**09-026/17 - THIRD-ROW SEAT HEADREST DOES NOT LOCK IN UPRIGHT POSITION**

**Bulletin No.:** 09-026/17

**Last Issued:** 06/20/2017

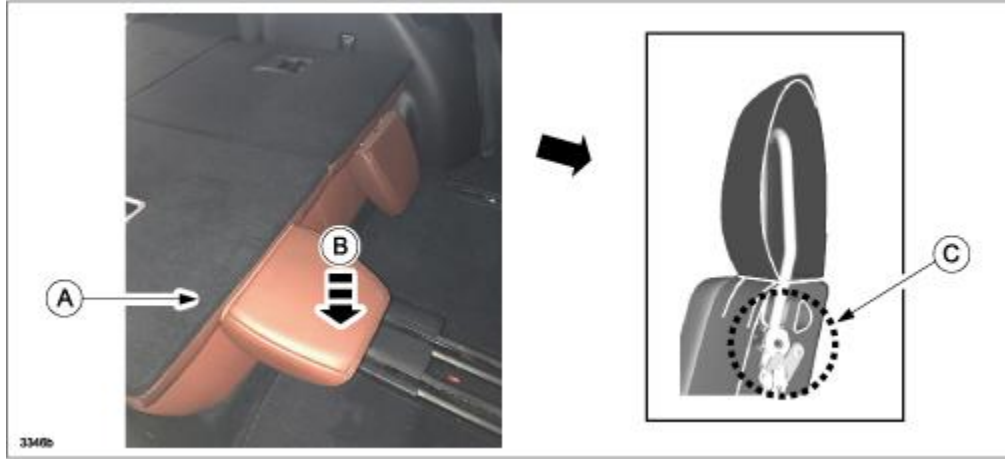
Some customers may complain that the third-row seat headrest(s) are loose (A) and do not lock in the upright position (B) or the headrest are locked in the forward-bent position (C).

These concerns are caused by improper operation while the seatback is folded down (A) and an excessive force is applied to the headrest (B) while it's in the upright locked position. When excessive force is improperly applied, this causes damage to the headrest lock mechanism (C).

Although this concern is caused by improper operation, the strength of the headrest lock mechanism has been increased to address the customer satisfaction issue. The related parts have also been modified. Customers having this concern should be instructed that they can prevent this issue from occurring by not applying excessive force to the headrests.

**REPAIR PROCEDURE**

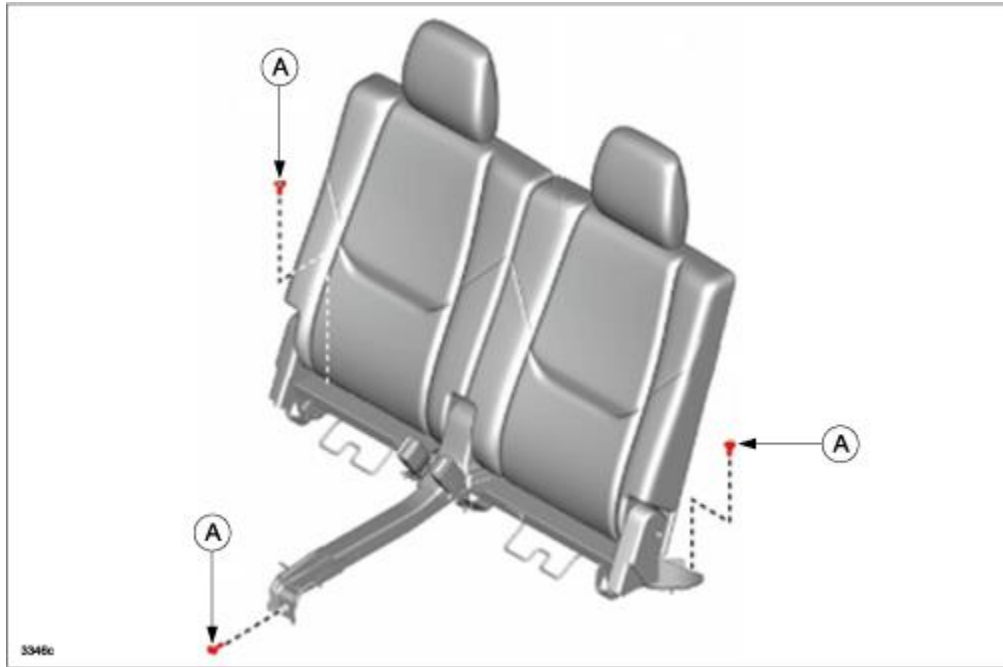
1. Verify the customer concern.
2. Replace the affected side third-row seatback component with a modified part according to the instructions

on MGSS online (THIRD-ROW SEAT BACK COMPONENT REMOVAL/INSTALLATION). Bolts - (A)
